Subject: Letter in opposition to ZC No. 24-15

Date: June 7, 2025

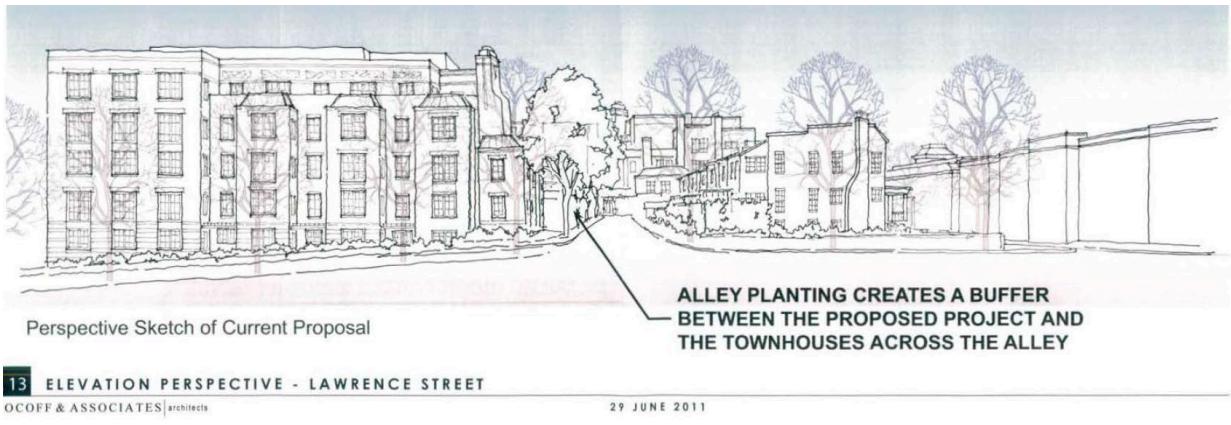
→ 901 Monroe Street should **use the existing curb cut on 9th street**; that alley entrance served the businesses and homes previously on the property (which were demolished by the developers). The **2011 design for this site used the 9th Street curb cut**; furthermore, to minimize adverse effects on the adjacent town homes.

→ **2011 design included tree buffers in the alley**—these elements should not have been abandoned in the current proposal. The ZC should require a green buffer in the alley.

→ The design should incorporate 45-degree setbacks along the alley to avoid adverse effects for the adjacent neighbors, and improved compatibility with the neighborhood.

→ The image below, of the 901 Monroe St 2011 design, shows appropriate setbacks facing the immediate neighbors, as well as a tree buffer in the alley.
